# Additional multifunction switch for special vehicle

**R 1200 RT Special Vehicles, (K52, OA13)**

**Service Information No. SI 61 001 18**

Figure: 1 Left additional multifunction switch  
Figure: 2 Right additional multifunction switch

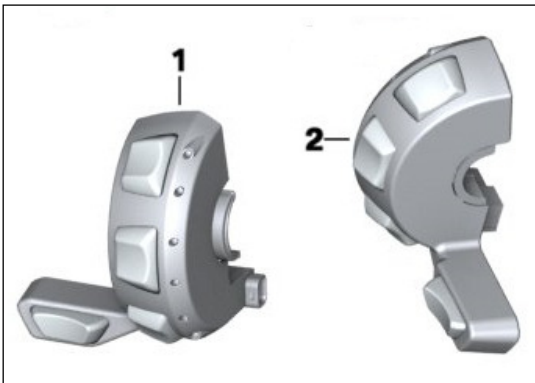
In the course of quality observations, BMW Motorrad has established that the additional multifunction switches for special vehicles may allow moisture in and can lead to a failure of the LIN bus. In the case of a failure the additional functions will no longer work.

For this reason the additional multifunction switches must be replaced on all affected vehicles.

Both the left and right additional multifunction switches must be replaced according to repair procedures.

61 31 017 (Replacing the left additional multifunction switch).

61 31 020 (Replacing the right additional multifunction switch).

### Identification of the additional multifunction switch

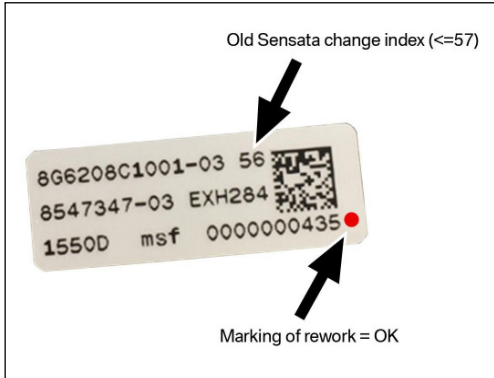
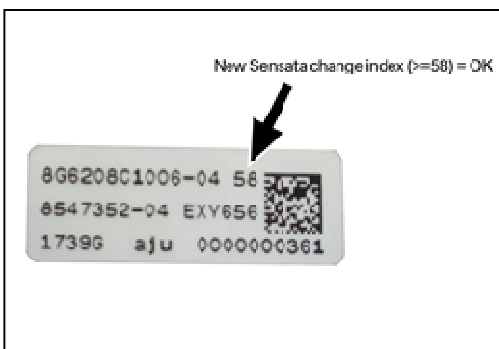
The additional multifunction switches are uniquely identified through a label on the housing.

The additional multifunction switches with the following identifications are OK. Only these may be installed in the course of the Technical Campaign:

Switches with a revision index  $\leq 57$  and with a RED or BLUE dot on the label  
(rework carried out by the supplier)

Switches with a revision index  $\geq 58$  on the label
